APPEAL SUMMARY

Appeal ID: 20404	Project Address: 5120 SE 28th Ave
Hearing Date: 5/15/19	Appellant Name: Kendra Duong
Case No.: B-014	Appellant Phone: 5038532006
Appeal Type: Building	Plans Examiner/Inspector: Renay Radtke Butts
Project Type: commercial	Stories: 2 Occupancy: B, R-3, S-2 Construction Type: V-B
Building/Business Name: Mosaic String Academy	Fire Sprinklers: Yes - basement, first floor, second floor
Appeal Involves: Alteration of an existing structure, Reconsideration of appeal, occ Change from M to B	LUR or Permit Application No.: 18-164227-CO
Plan Submitted Option: pdf [File 1] [File 2] [File 3]	Proposed use: music school, residential

LAMBERT HOUSE ALTERATIONS

Re: 5120 SE 28th, floor-ceiling improvements for IIC and STC

FIRST FLOOR PLAN

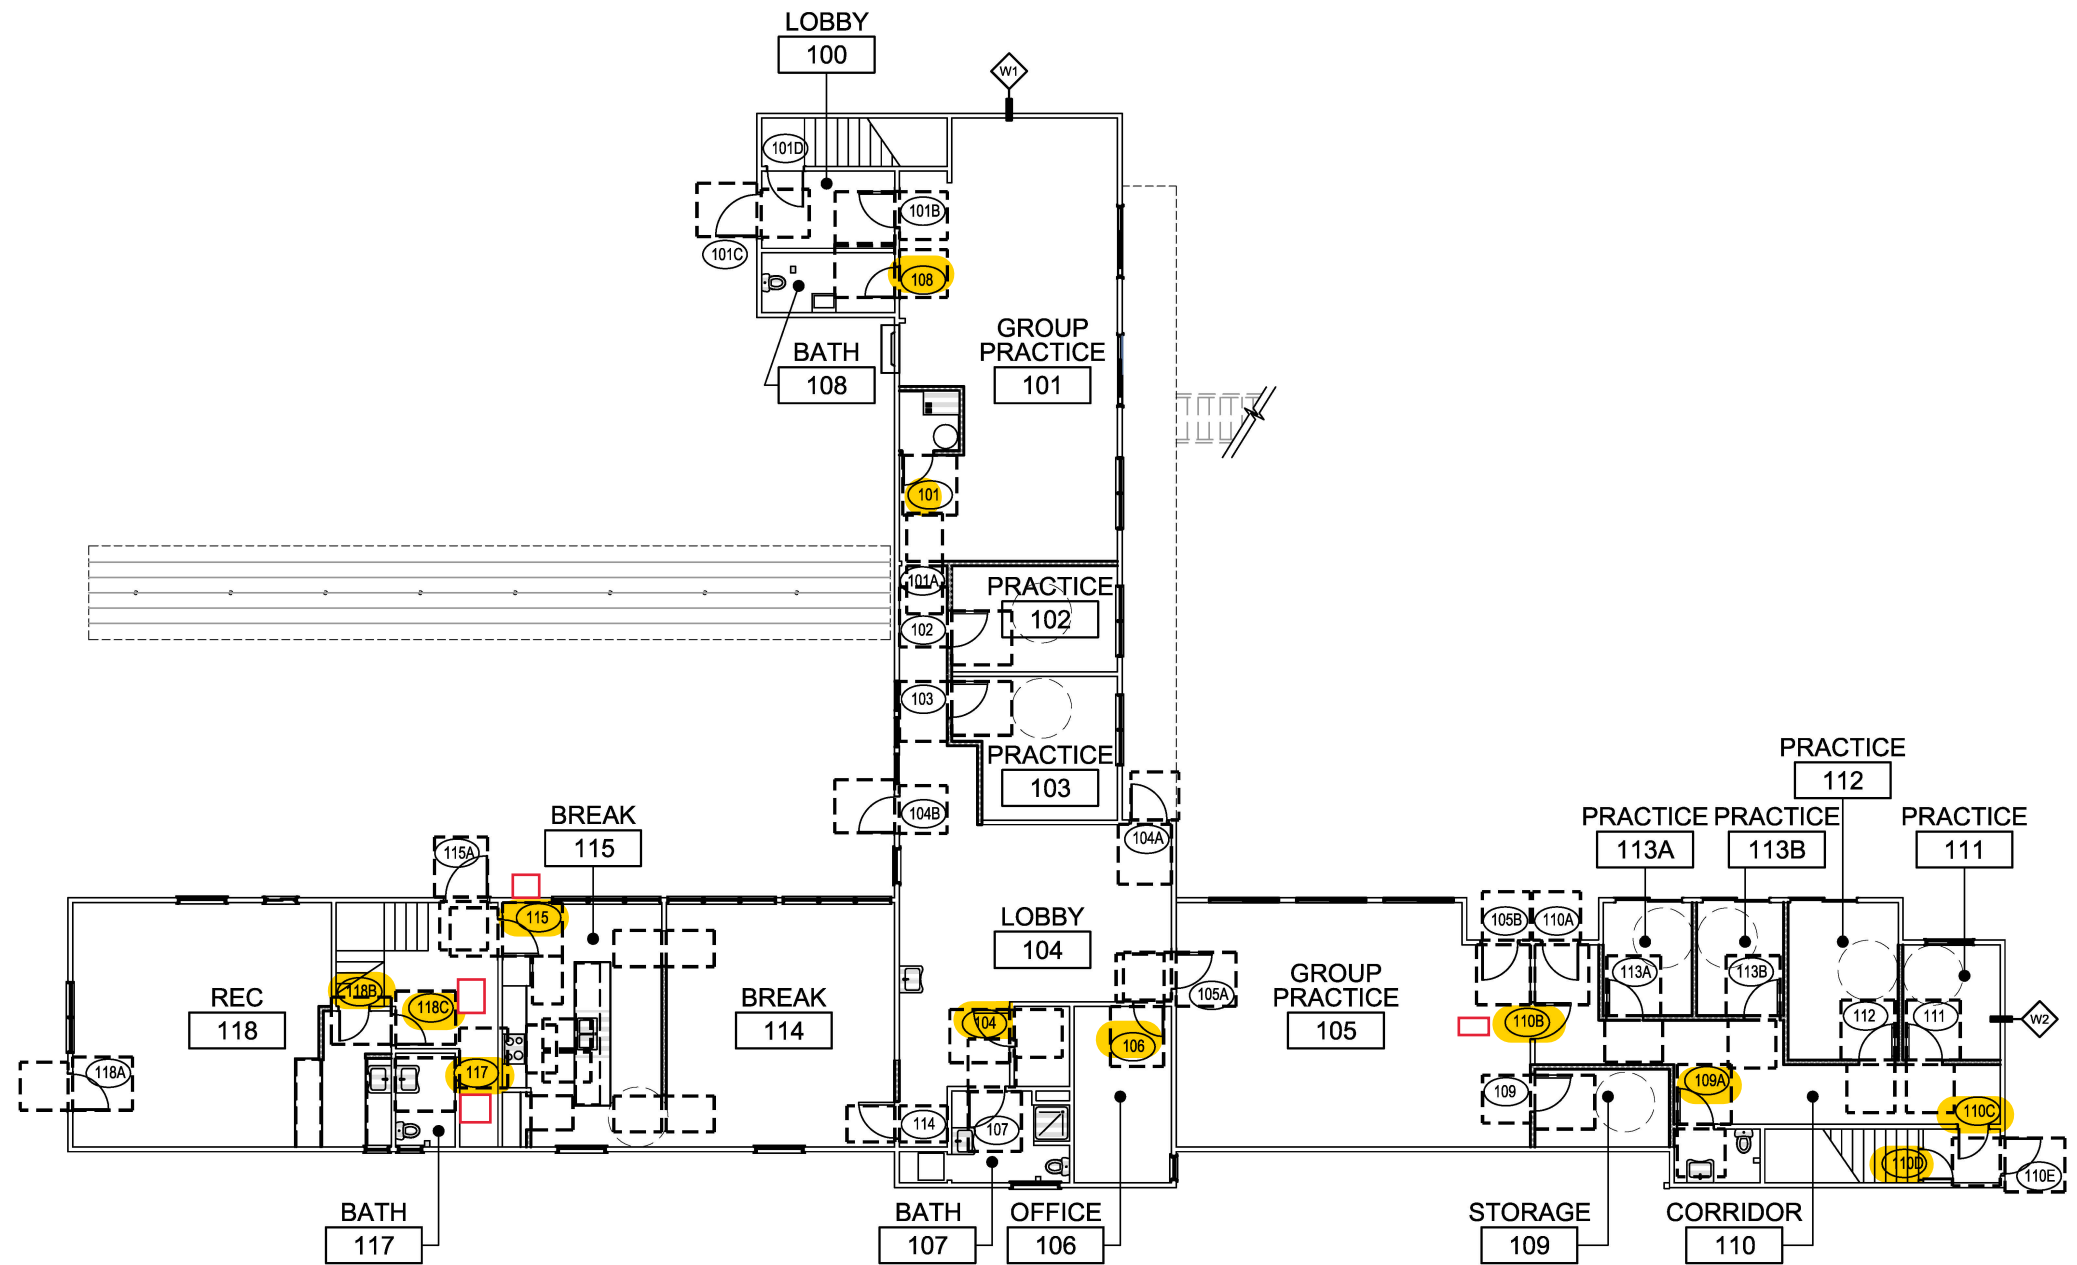
Code Section	ossc 1008.1.1
Requires	The minimum width of each door opening shall provide a clear width of 32".
Proposed Design	<p>This is an existing building built in 1946 of type VB construction and is largely intact compared to its original configuration. It was built as the residence and operations for the Lambert Gardens which was in operation until the late 1960's. It consists of 3 wings, two of which include a basement, and two of which are 2 stories.</p> <p>The building has a full NFPA 13 fire sprinkler system installed in 2005, as would be required in the current building code, but it also has a fire alarm system complying with NFPA 72, which would not be required per the current building code.</p> <p>There are 8 existing exterior doors on the first floor, which is 4,978 square feet. All exterior doors are 36" or 48" wide. Two exits are required based on occupant load.</p> <p>All new interior doors will be 36". Doors that provide less than 32" clear width are doors 101, 104, 106, 108, 109A, 110B, 110C, 110D, 115, 117, 118B and 118C.</p>

Reason for alternative	It would be impractical, in some cases technically infeasible, and cost prohibitive to enlarge all existing non-compliant doors. Note that this same appeal was granted in 2001 for temporary daycare use without an alarm or sprinkler system.

- 1. Reduction of Sound Transmission Class (STC) rating of floor / ceiling assembly: **Granted as proposed.**
 - 2. Reduction in minimum required door width: **Granted provided doors 110B, 110C and 115 are replaced with 3/0 x 6/8 doors.**
- Appellant may contact John Butler (503 823-7339) with questions.**

ASSEMBLIES

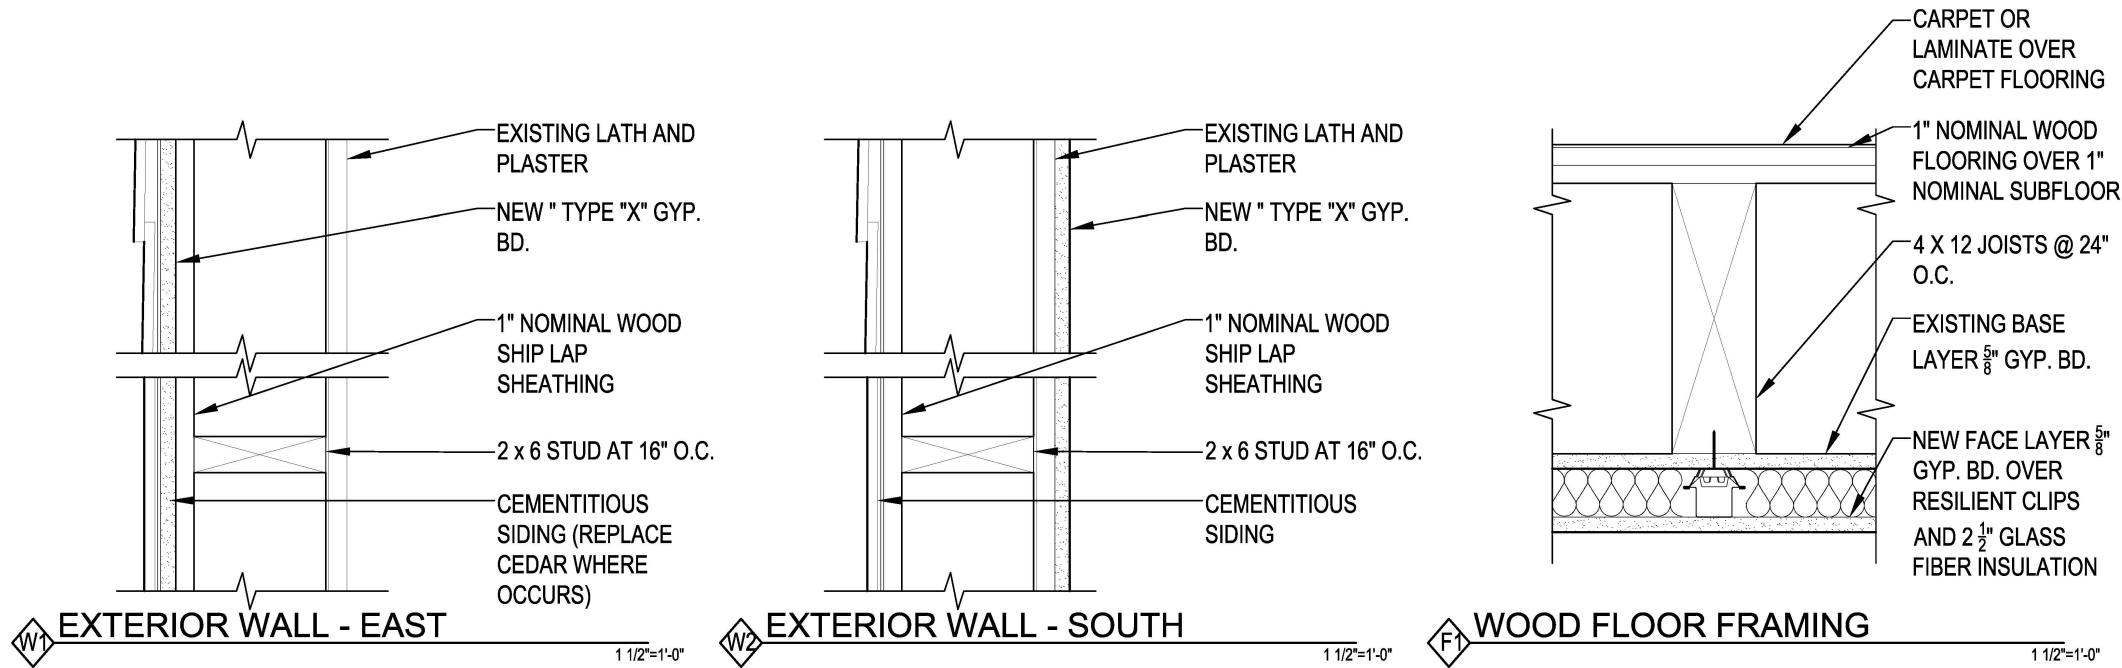
Code Section	ossc 1207
Requires	Floor assemblies separating dwelling units from other occupancies contiguous to them in the same building shall have an STC rating of not less than 50, and an IIC rating of not less than 50.
Proposed Design	<p>This is an existing building built in 1946 of type VB construction and is largely intact compared to its original configuration. It was built as the residence and operations for the Lambert Gardens which was in operation until the late 1960's. It consists of 3 wings, two of which include a basement, and two of which are 2 stories.</p> <p>We propose to add a layer of 5/8" type "x" gypsum board over resilient clips which will create a 2" cavity which will be filled with insulation. This will increase the performance from an STC of 37 to an STC of 42-43. The IIC is estimated to increase from 31 to over 50 due to the fact that there is carpet in all areas of the second floor other than restrooms and utility spaces. The acoustical consultant has deemed this the most practical means of improvement.</p>

Reason for alternative	<p>The existing floor construction between the B occupancy on the first floor and the existing R-3 occupancy on the second floor consists of 4 x 12 joists at 2'-0" on center with a 5/8" gypsum board ceiling, and 3/4" (1" nominal) wood floor over 3/4" (1" nominal) subfloor. In most areas the finished floor consists of carpet, or laminate over carpet, over the original wood flooring.</p> <p>Note that the lower level of this building has changed occupancy numerous times over the years but the second floor has remained a residential occupancy since 1946.</p> <p>Business hours for the first floor tenant are 2pm to 8pm. Residential tenants will be aware of the ground floor tenant use and hours of operation and may voluntarily enter into a rental agreement.</p>

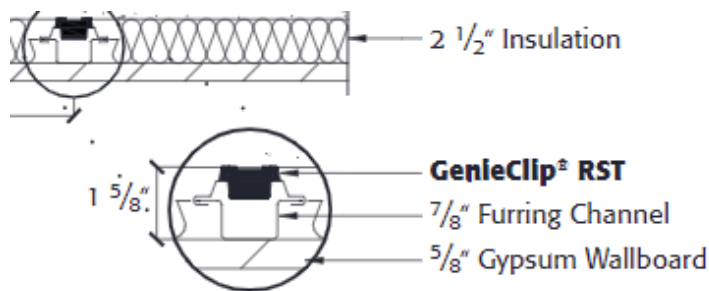
5. Using a clip (RSIC-1, from Pac International or Genie Clip from Pliteq) and steel furring channel to hang a second layer of gypsum, creating a 2" deep cavity that is filled with batt glass fiber insulation would increase performance to STC 42-43 and IIC 40-44. See the sketch below.

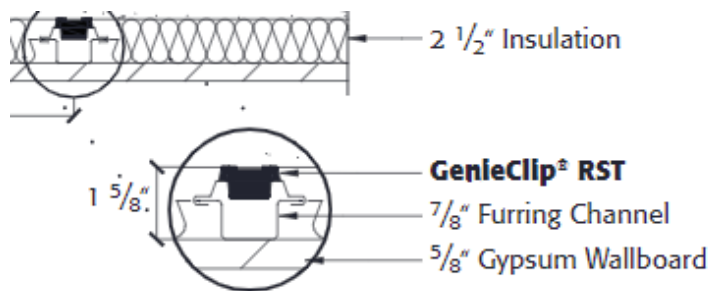
5. Using a clip (RSIC-1, from Pac International or Genie Clip from Pliteq) and steel furring channel to hang a second layer of gypsum, creating a 2" deep cavity that is filled with batt glass fiber insulation would increase performance to STC 42-43 and IIC 40-44. See the sketch below.
